Amendments to the Drawings

REMARKS

FIG. 5

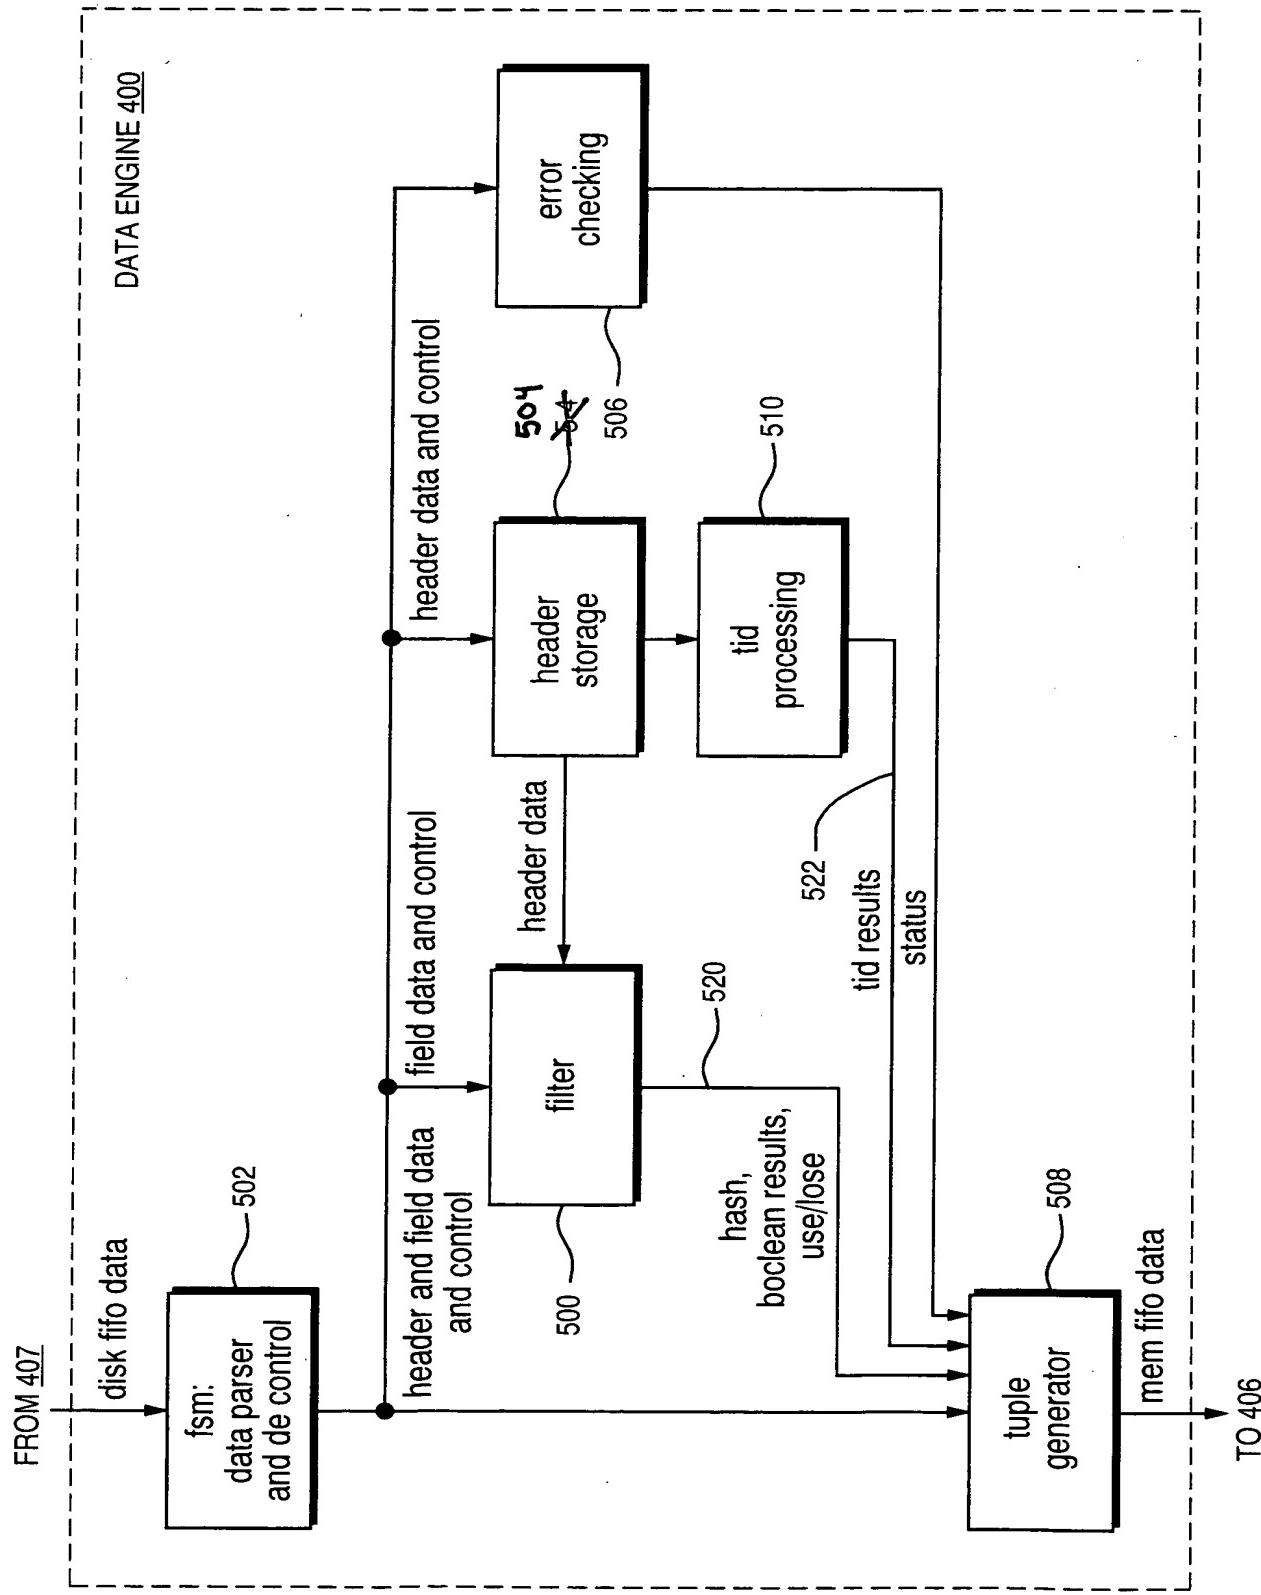
In FIG. 5, reference number 54 is changed to 504.

reference characters 301, 302, 304, 306, 308, 310, 312, 314, 322, 324, 330, 334, 336 and 338 are now noted in the appropriate places in the specification;
the PSDP PREP in FIG. 3 is now labeled 330;
the JPU DIAGS in FIG. 3 is now labeled 332; and
the header storage in FIG. 5 is now labeled 504.

FIG. 3

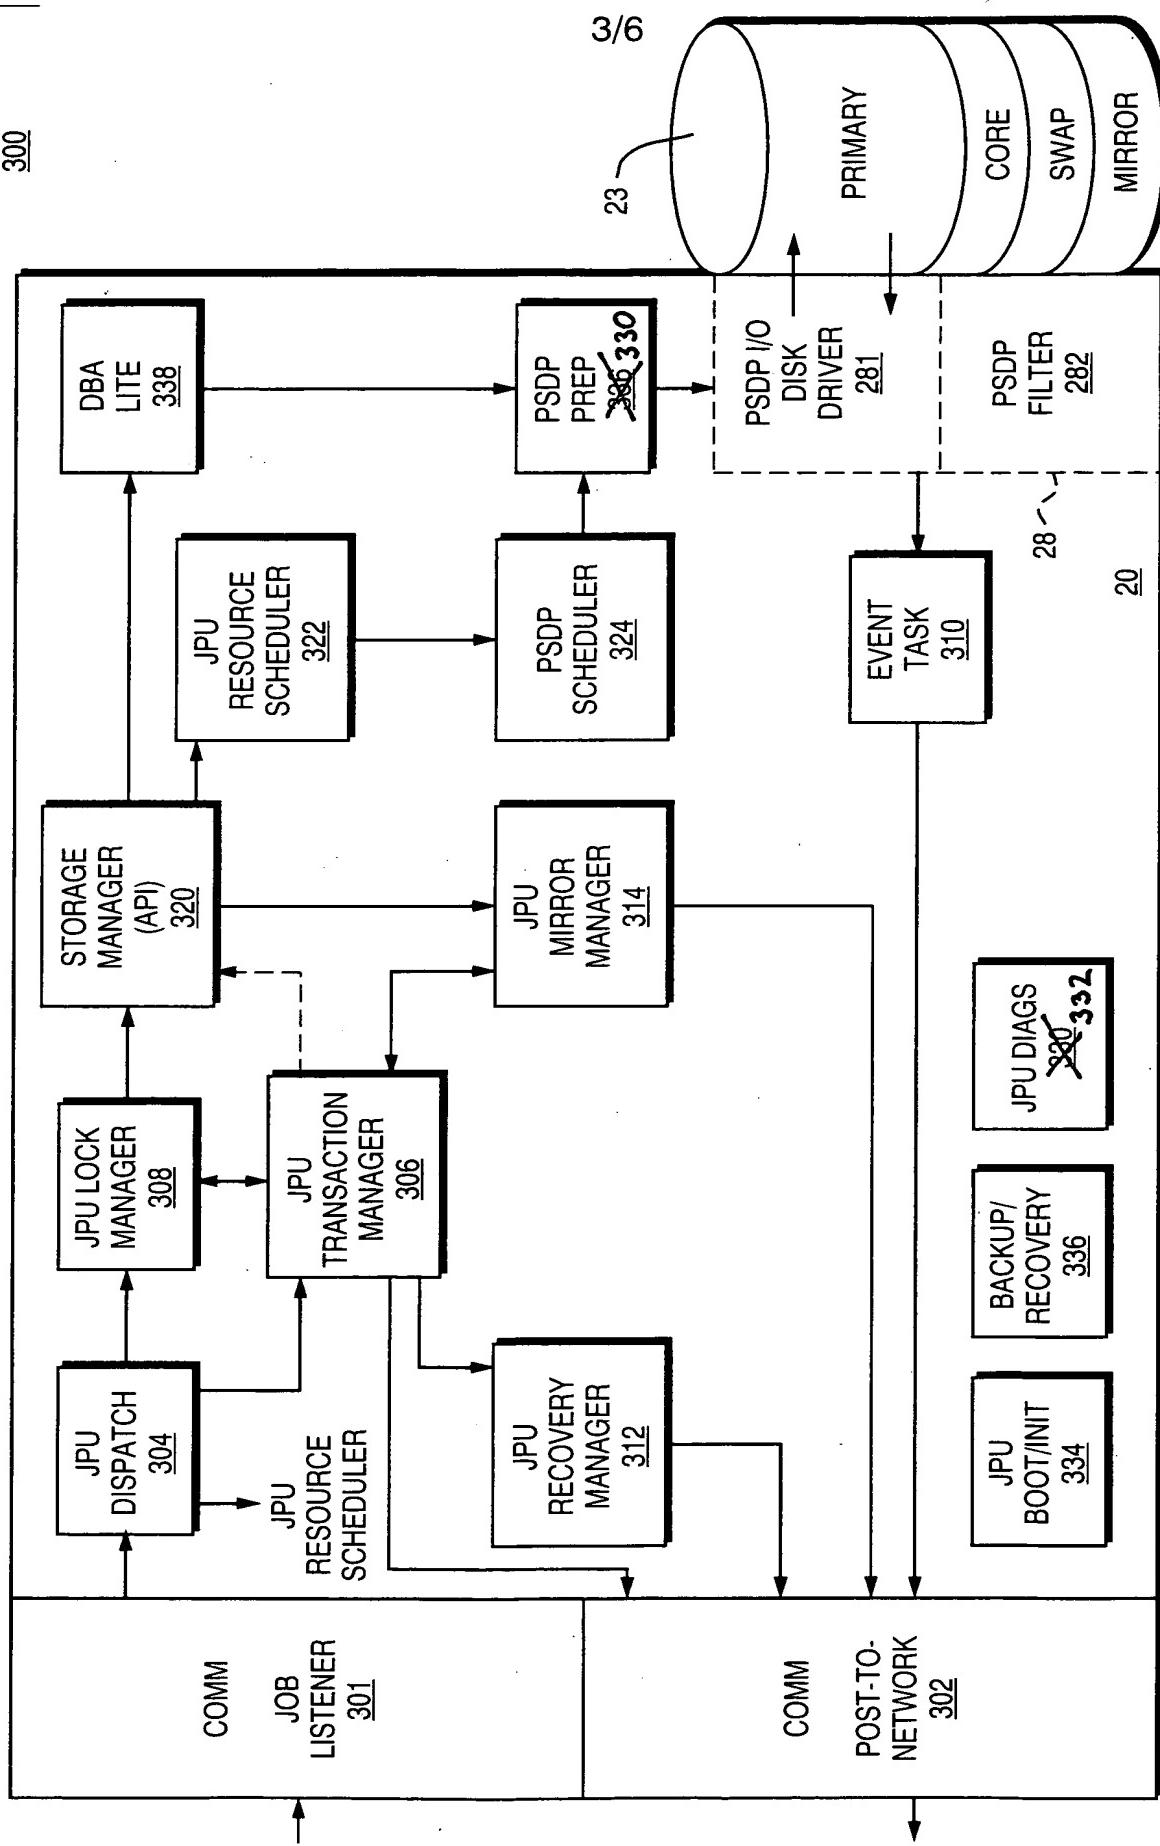
In FIG. 3, reference number 336 (PSDP PREP) is changed to 330.

In FIG. 3, reference number 330 is changed to 332.
